RE: Submission on Holt Precinct Code Draft Variation 361 Kippax Group Centre

Thank you for the opportunity to comment on Draft Variation 361 (DV361) to the Territory Plan proposing additional controls within the Holt Precinct Code following the release of the final Kippax Group Centre Master Plan. I am the Lessee of Block 59 Section 51 Holt (Kippax Fair Shopping Centre) and seek to expand the core shopping precinct as outlined in the Master Plan and Territory Plan Variation.

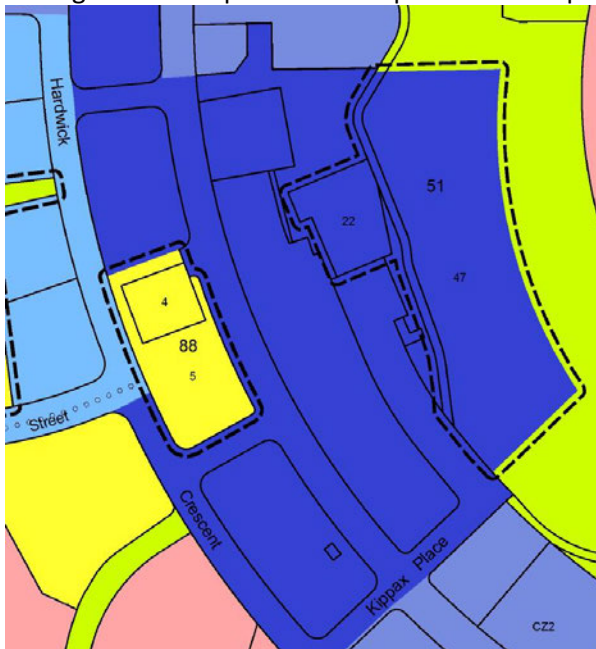
Kippax Fair, in response to the inclusions in DV361, the discussions with the Belconnen Community Council, and discussions with representatives from Ginninderry estate prepared the design concept below that seeks to capture the key matters of interest and address matters of concern. Kippax Fair's site configuration (Attachment 1) demonstrates the following:

The proposed site design relies on a few specific matters for consideration being:

- Flexibility to development along the Moyes Crescent open space active edge and its siting;
- Definition of the northern and southern extent of the development parcel to allow sensible integration with the existing road network and providing opportunities to align the new road in an optimal way (again while having regard to the current road network geometry);

- Creation of loading dock spaces that allow both functionality to commercial use while retaining amenity to surrounding use (including nearby residences);
- Upon request from the Belconnen Community Council, the use of part Sections 89 and 88 for Open Space/community use to create a true community focused precinct at the heart of the Kippax Group Centre; and
- Opportunities to reserve Section 89 for community use (if required in the future), again by request of the Belconnen Community Council.

Territory Plan Map variation as per DV361

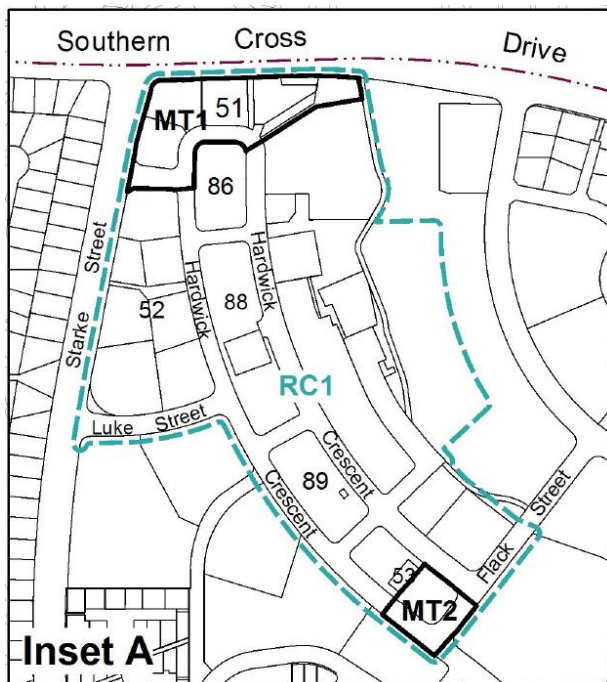
Suggested change to the Territory Plan map

Retain zoning expression as per DV suggestion. However, to enshrine the opportunity for part Section 88 and part Section 89 to be used for community use we suggest the following change to be implemented.

- Extend the CFZ Community Facility zone extent over part Section 89 and a larger part of Section 88;
- Alter the northern boundary of the extended CZ1 – Core zoning over Section 47 to retain Public Open space zoning; and
- Extend the CZ1- Core zoning to the south to allow integration of future loading dock use with existing road geometry.

The figures below provide a comparison of the proposed Territory Map change against DV361.

Inset A, Holt Precinct Map as per DV361

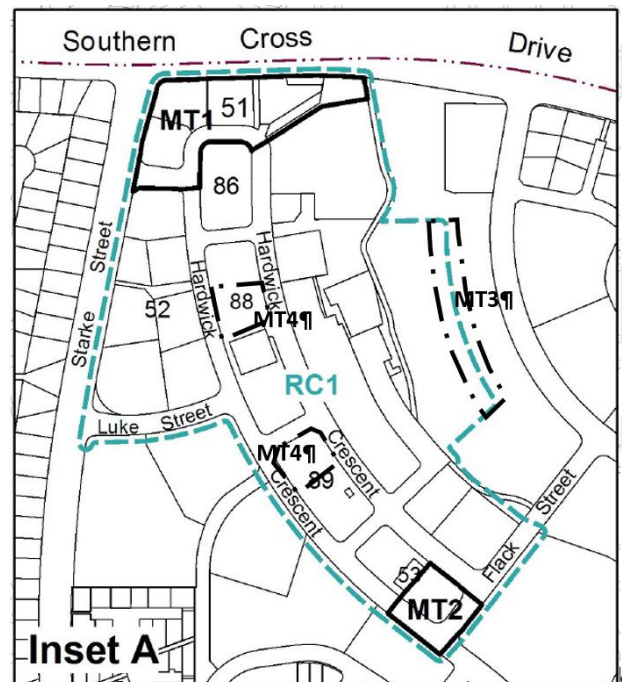
Suggested change to the Holt Precinct Map/Code

In order to provide flexibility over the existing Section 88 and 89 carparking areas for potential expansion of the central community hub offering we suggest the change in zoning while retaining the existing car parking use by introducing an MT4 overlay to these areas allow the current use over CFZ-Community Zoned land.

We also propose the introduction of an MT3 overlay area with associated uses and creation of new rule/criteria (see below) detaining the development opportunity within this area as a way to provide flexibility to the zoning map boundaries that will limit design resolution and development outcomes as set out above.

MASTER PLAN

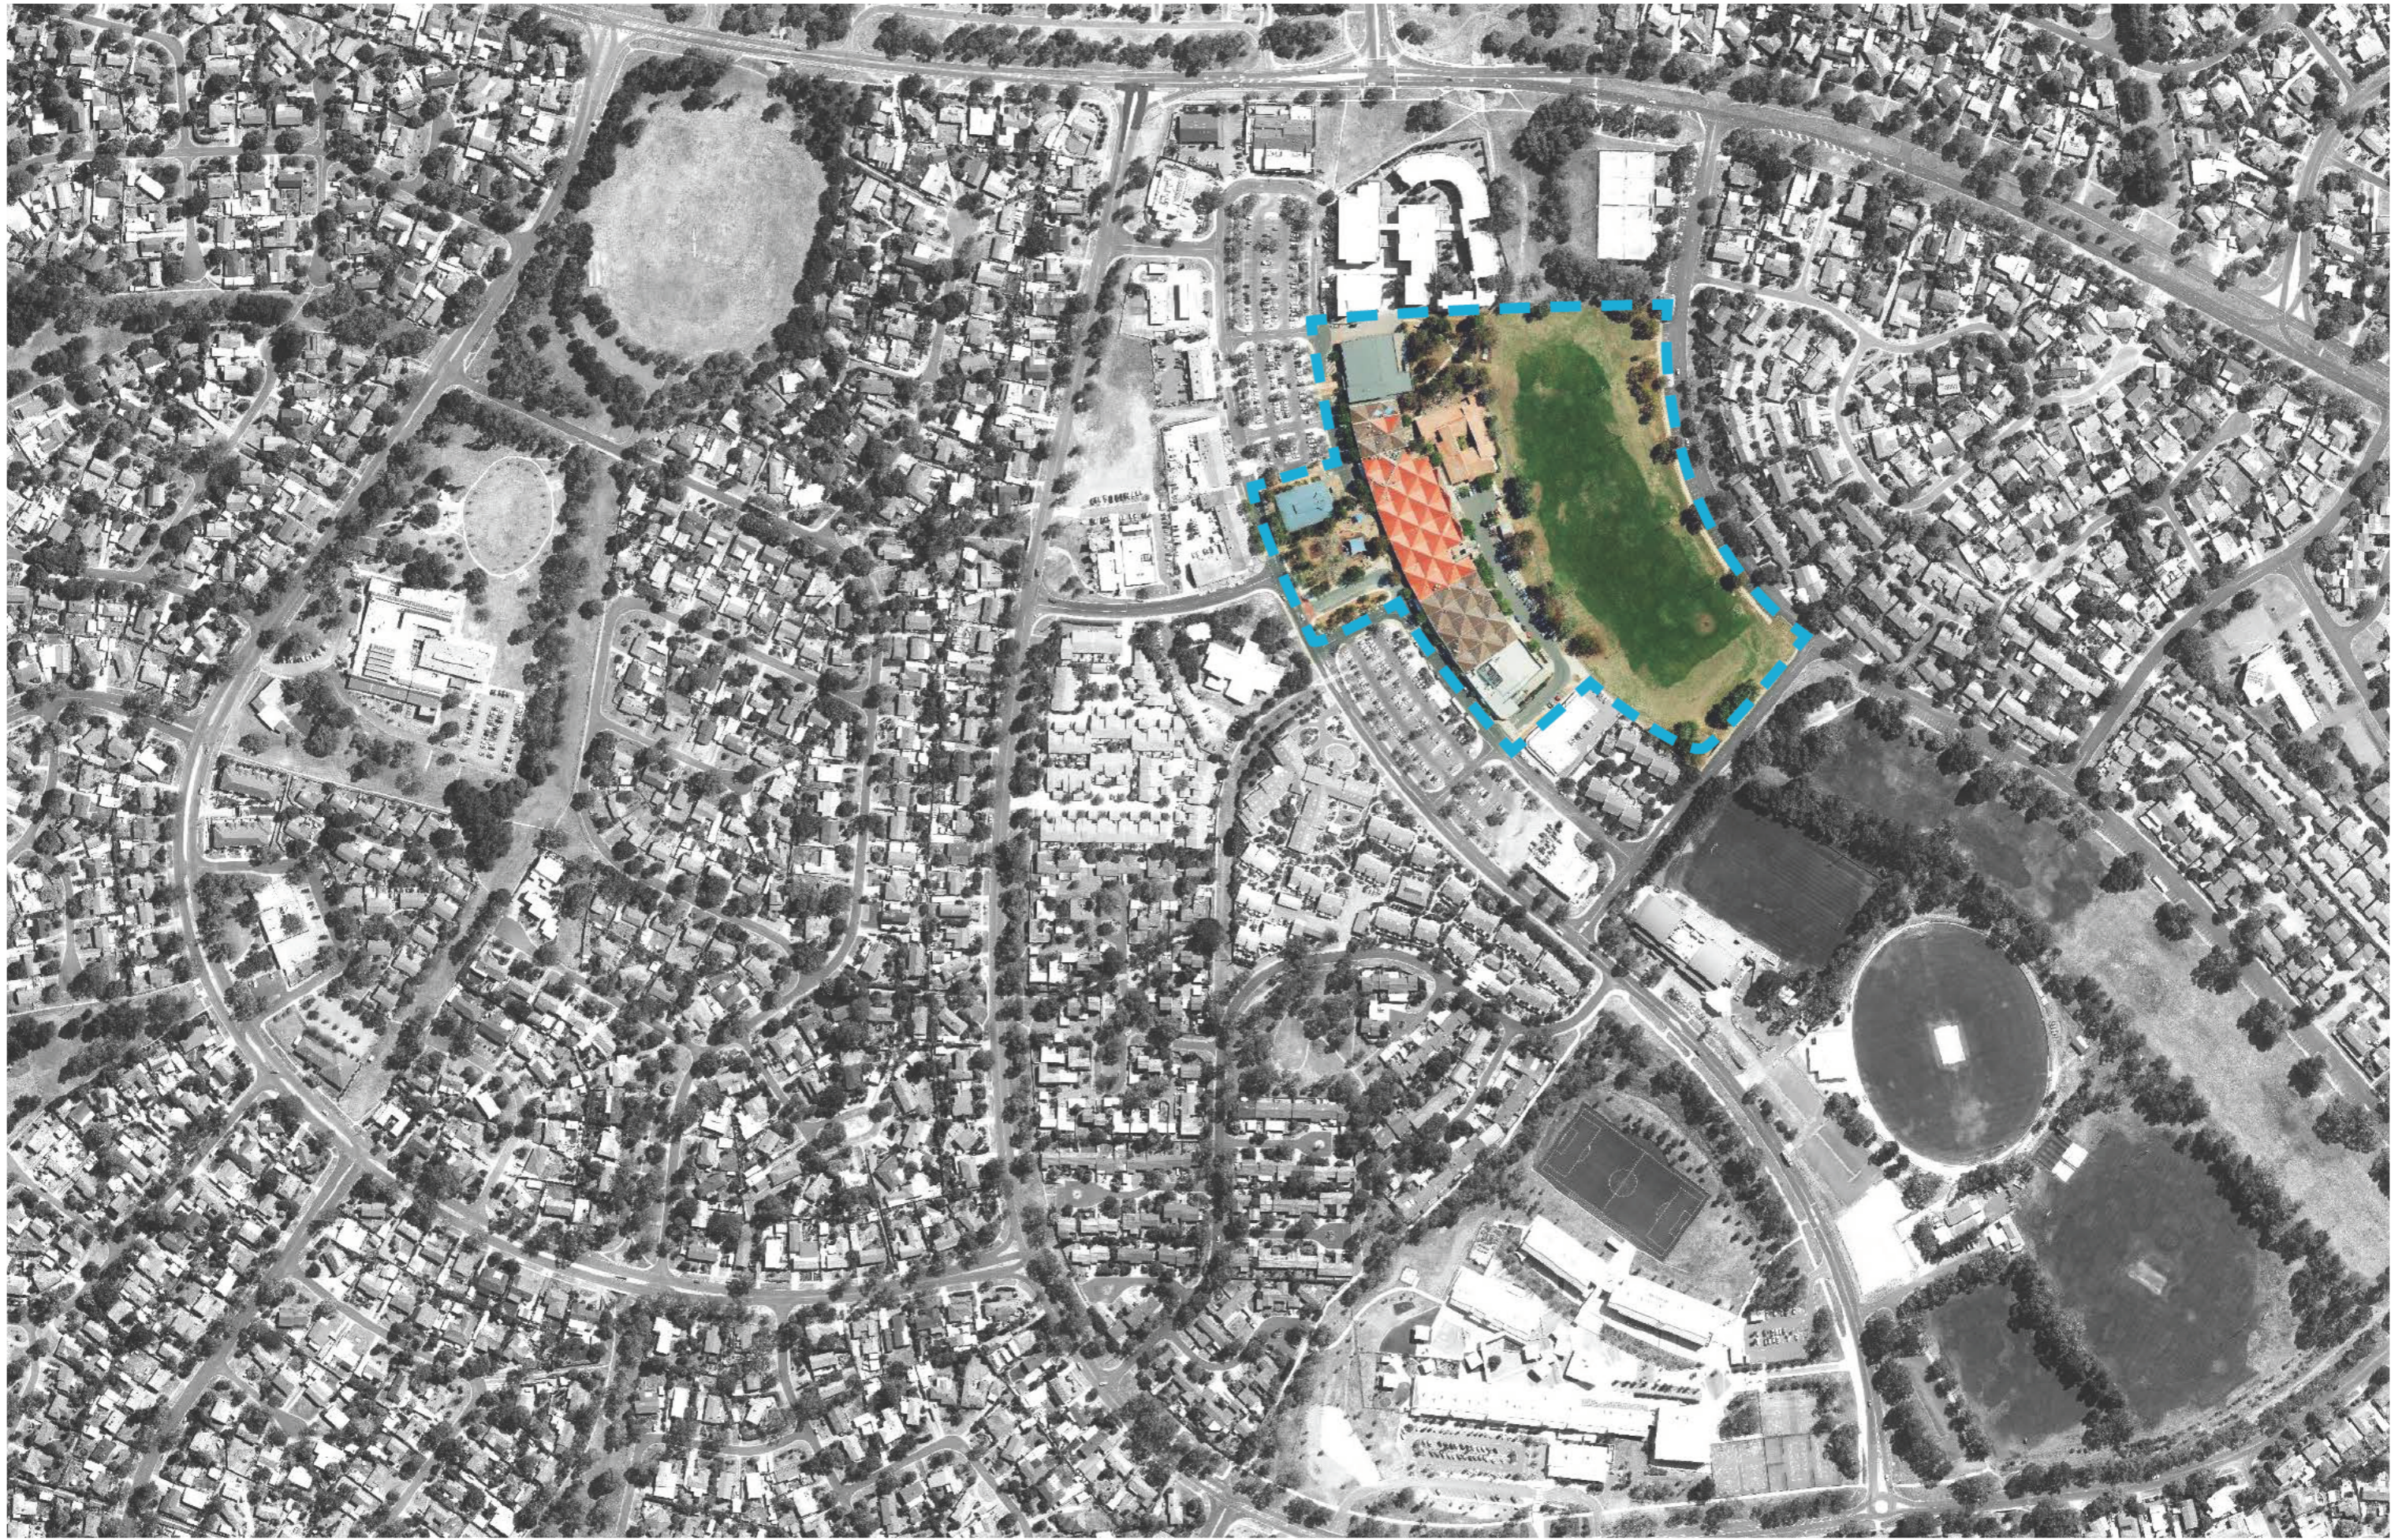
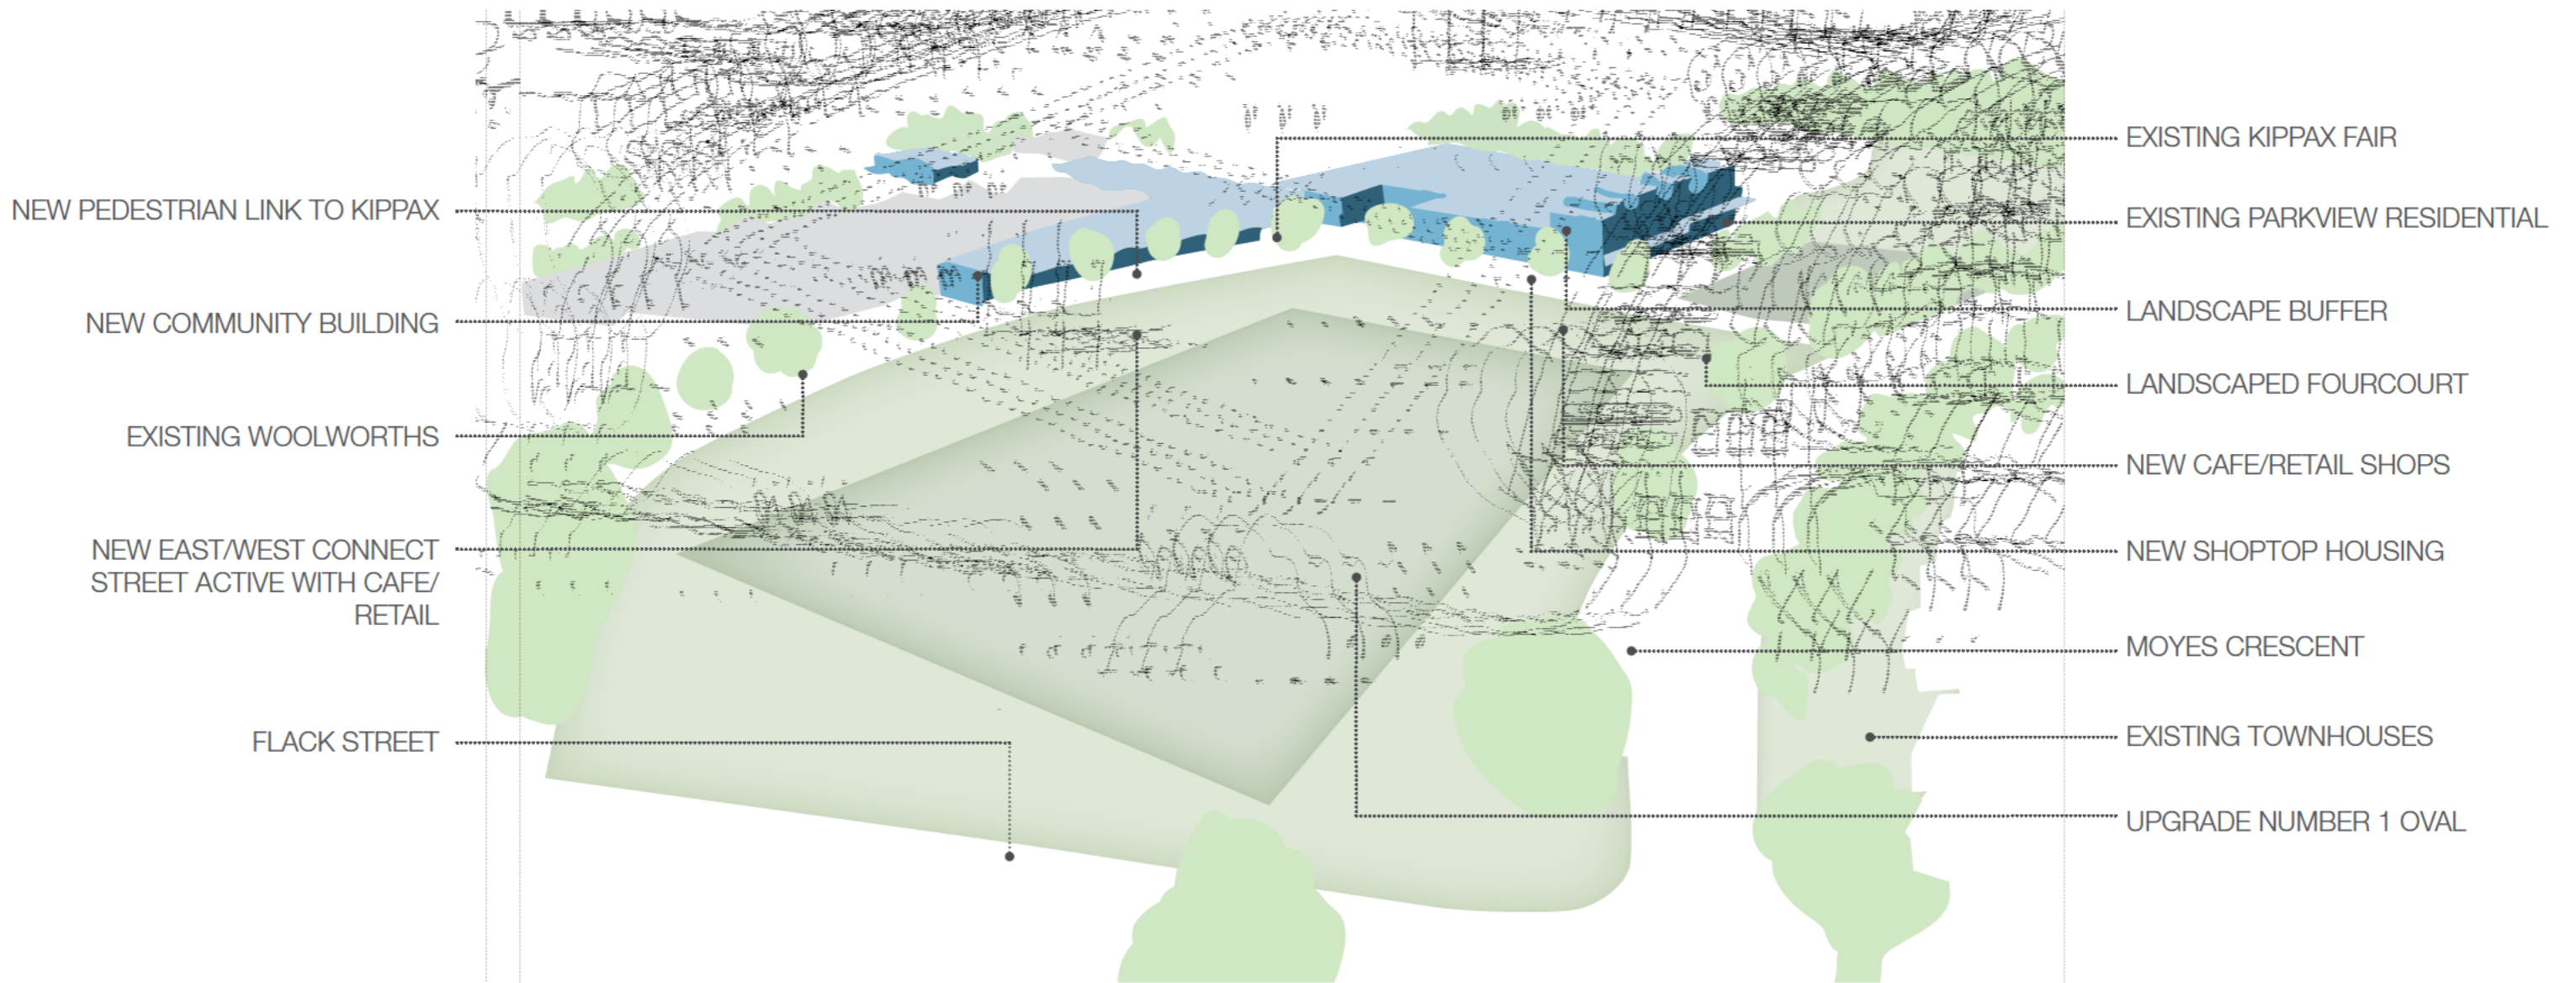
Noting the above considerations and the importance of open space connectivity and use objectives, we have explored the principles of an alternative site configuration that could be implemented in DV361. The configuration proposed by Kippax Fair (at Attachment 1) will have **no net change/loss** to the size/area of public open space that is retained along Moyes Crescent compared to that depicted in the draft variation. Importantly, it facilitates the delivery of the Kippax Master Plan's objectives and the basis for DV361.

The design adopts the Hardwick Crescent geometry as the setback control point, as opposed to Moyes Crescent geometry. This will allow some parts of the development to enjoy an offset from Moyes

Crescent in excess of the suggested 50 metres, whilst balancing the geometrically “pinched” part of the development site to encroach somewhat into the 50 metre buffer area. The combination of enlarged setback and encroachment results in the same or a larger quantum of useable open space land to be retained to what is expressed in the Draft Variation presented. It is important to note that as part of our investigations into a varying setback condition along the eastern edge, Kippax Fair has commissioned hydrological studies to consider design options for the green space between the future retail hub and Moyes Crescent in association with stormwater management improvements in this location within Holt.
